E. Concept Plan – Remarked (date: 12/20/2021)

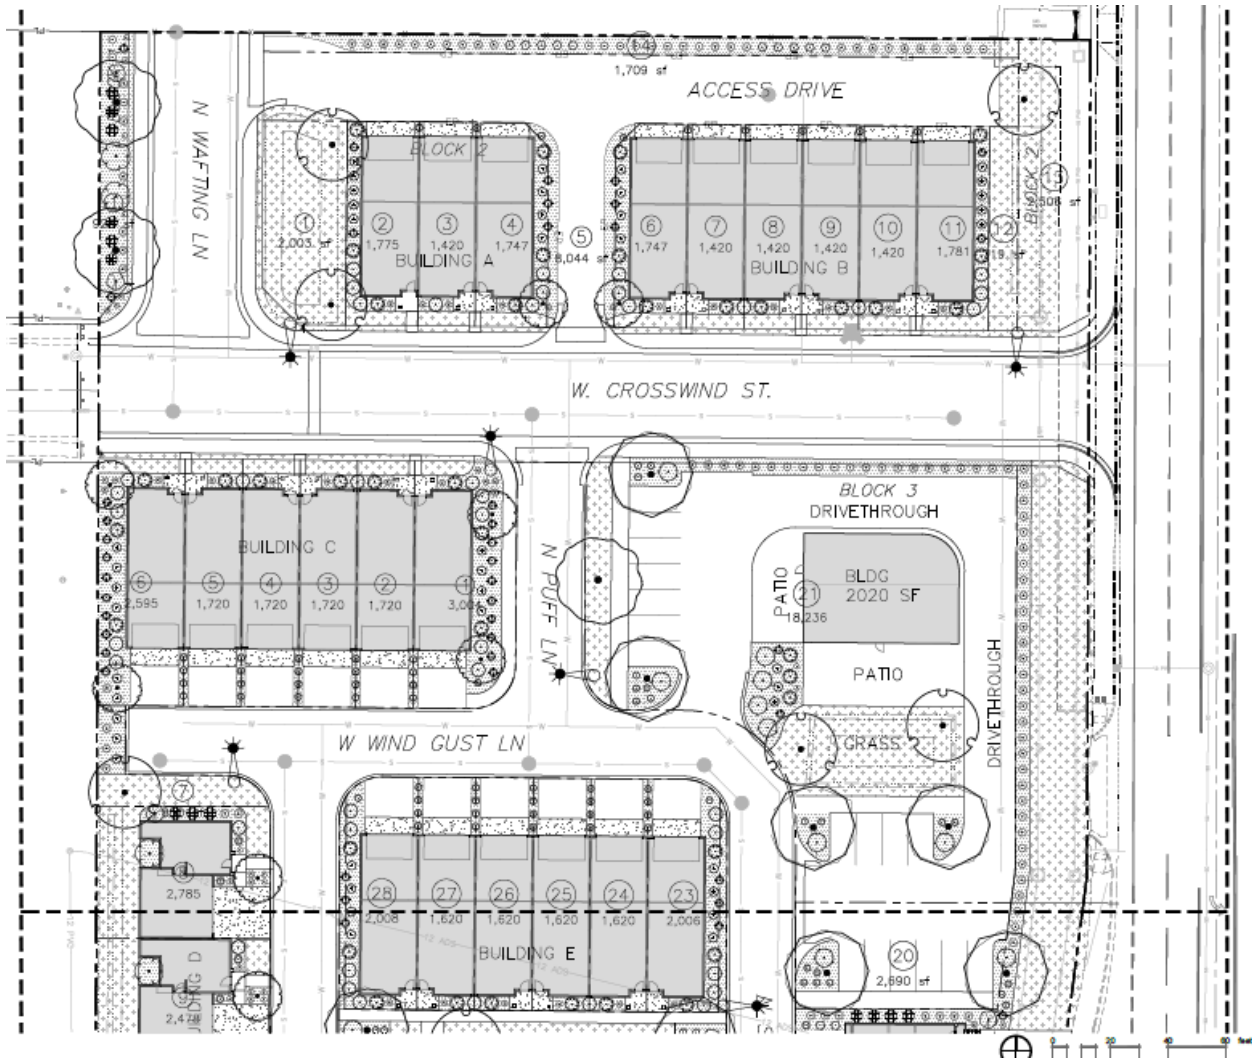
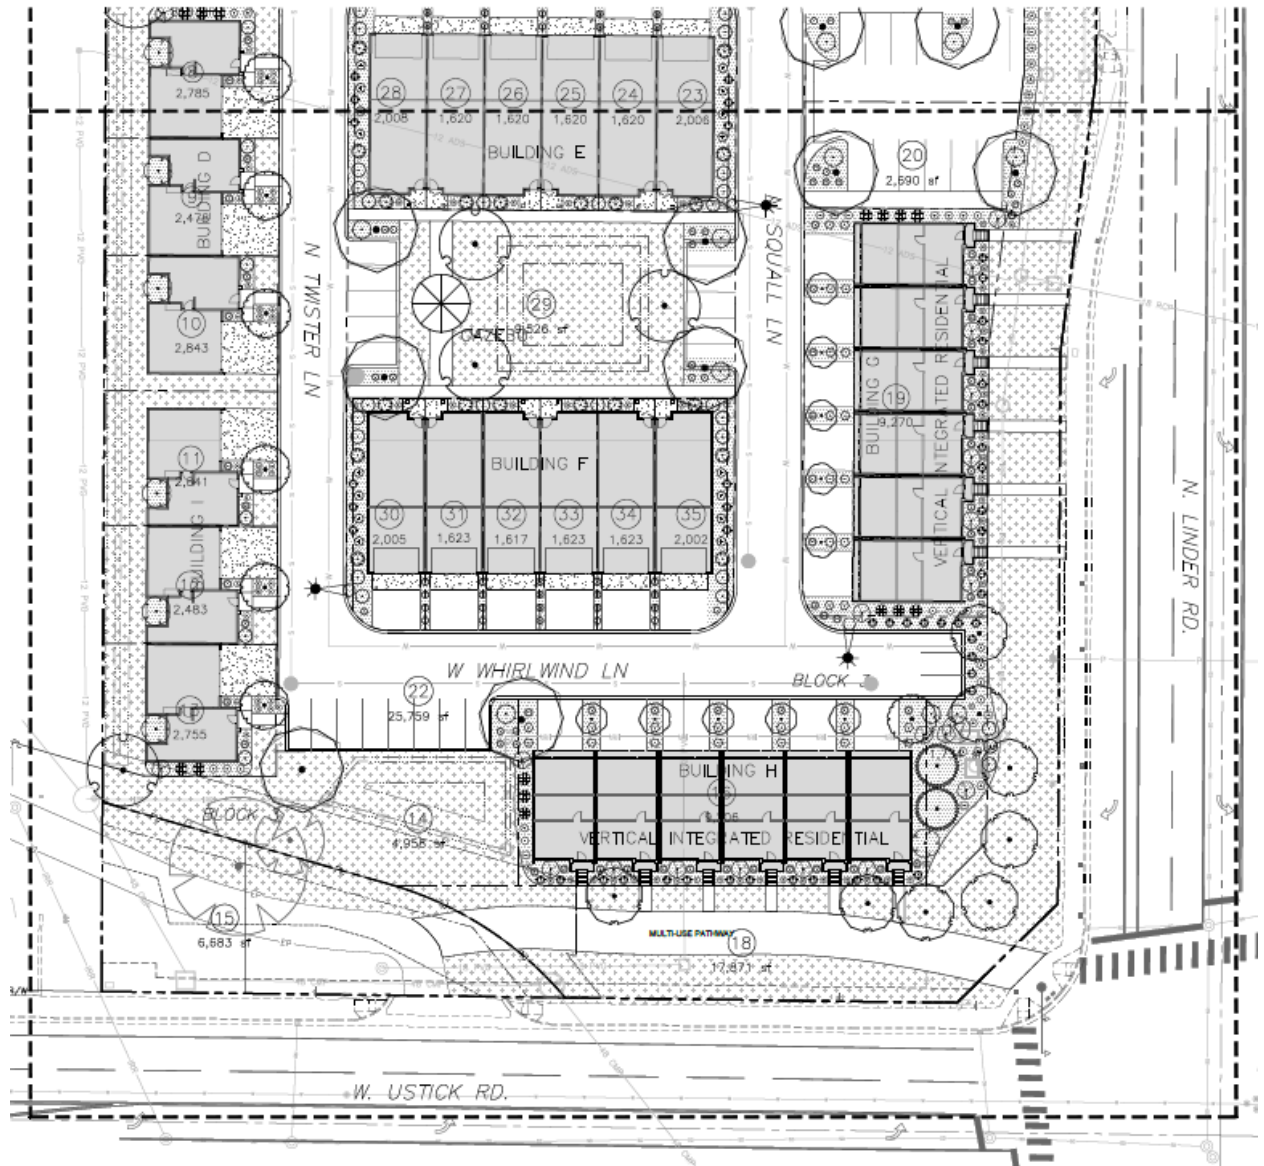
The concept plans show a townhouse row indicated as “Building D” along the western property line as close as 30 feet from existing residences. Staff does have concerns with the impact of a “wall effect” of these townhomes on the Windsong No 2 Subdivision. **As a condition of approval, staff recommends Building D be broken into at least two groups of buildings, with the break occurring approximately in the vicinity of Lot 19, Block 3 of the Windsong Subdivision No 2.**

On the north side of W. Crosswind St., the plat indicates a private alley (east-west) and N. Puff Ln (north-south). Neither of these roadways meet minimum requirements. Alleys need to connect on both ends to serve as fire lanes, whereas the alley that is shown north of Buildings A & B dead-ends to the east. Also, N. Puff Ln is shown to be 23 ft. in width whereas 24' ft is the minimum. The applicant should revise this portion of the plat to meet the requirements of UDC 11-6C. This could be done by widening the alley and N. Puff Ln to at least 24 ft. in width, or converting the "alley" to a common drive and removing units to comply with the maximum allowed number of units allowed per UDC 11-6C-3-D (4 total, with no more than 3 on one side).

The applicant should note if Buildings A&B were converted to vertically-integrated residential projects fronting along W. Crosswind St., the alley could be redesigned as a 25-foot wide commercial drive aisle as long as it met the requirements of UDC 11-3C-5. This would increase the commercial uses desired in the area. If the applicant is amenable to this request, staff would recommend that the concept plan be modified prior to the City Council hearing.

Staff supports providing multiuse pathways but finds the configuration as proposed redundant and unnecessary. At the east along N. Linder Rd., the plans propose a 10 ft. wide pathway directly adjacent to the existing 7 ft. wide sidewalk. Similarly, the applicant proposes to provide a 10 ft. wide pathway slightly offset from the existing sidewalk on W. Ustick Rd. **In order to reduce impervious surfacing, unnecessary construction and increase landscaping, staff believes it is unnecessary to provide the additional pathway along N. Linder Rd and that the existing 7 ft. wide attached sidewalk should remain. The sidewalk along W. Ustick Rd should be widened to 10 ft. wide, the pathway shown directly south of Building H should be eliminated, and the connection between the existing Five Mile Creek Pathway and the W. Ustick Road Pathway should be shifted further to the west (this has been red-marked on the concept plan shown in Exhibit IX). Also, staff has concerns with the multiple walkways connecting Buildings G and H to the pathways. For less conflict points, staff recommends the plans be revised to include only one walkway connection to the pathways from each building.**

The concept plan as submitted indicates an alley or private drive directly abutting the residentially-zoned parcel to the north. To provide buffering and a softer transition, staff recommends a 5 ft. wide landscape buffer in this area, landscaped as required by UDC 11-3B-8.

- h. Building D along the western property line shall be broken into at least two groups of buildings, with the break occurring approximately in the vicinity of Lot 19, Block 3 of the Windsong Subdivision No 2.

- d. Parking spaces shall be subtracted out of all areas indicated as useable open space.
7. The landscape shall be revised as follows:
 - a. The additional pathway along the south perimeter shall be removed, and the sidewalk along W. Ustick Rd shall be widened to a 10 ft. wide pathway along the property line, with a 10 ft. wide connection to the Five Mile Creek Pathway at the west perimeter of the site.

- b. The pathway shown along N. Linder Rd shall be revised to include only the existing 7 ft. wide sidewalk.
 - c. There shall be no more than one walkway per building connecting to the pathways and sidewalks along W. Ustick Rd. and N. Linder Rd.

- d. A landscape buffer of at least 5 ft. in width, meeting the planting requirements of UDC 11-3B-9, shall be required along the northern property line or as otherwise required by UDC 11-3B.
